**Environmental Impact Statement for Authorization  
for Incidental Take and Implementation of  
Fruit Growers Supply Company's Multi-Species  
Habitat Conservation Plan**

**NOAA National Marine Fisheries Service  
United States Fish and Wildlife Service**

**Volume II  
Appendix F: Responses to Comments**

**June 2012**

Figure 2: Carbon storage in old-growth versus 60-year old forests. Harmon et al. 1990. The following chart shows the carbon storage within the components of a young forest and old forest ecosystem.

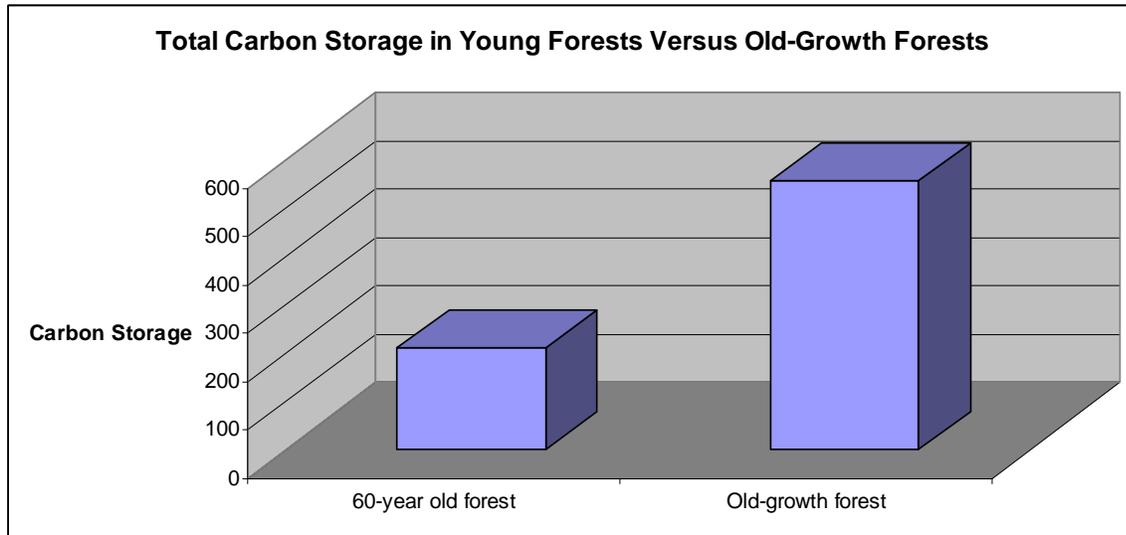
The following chart shows the difference in carbon stores between an old-growth forest ecosystem and 60-year-old forest. Much of the difference—roughly 350 Mg C/hectare—is released through logging (Harmon et al. 1990):<sup>31</sup>

8 cont'd
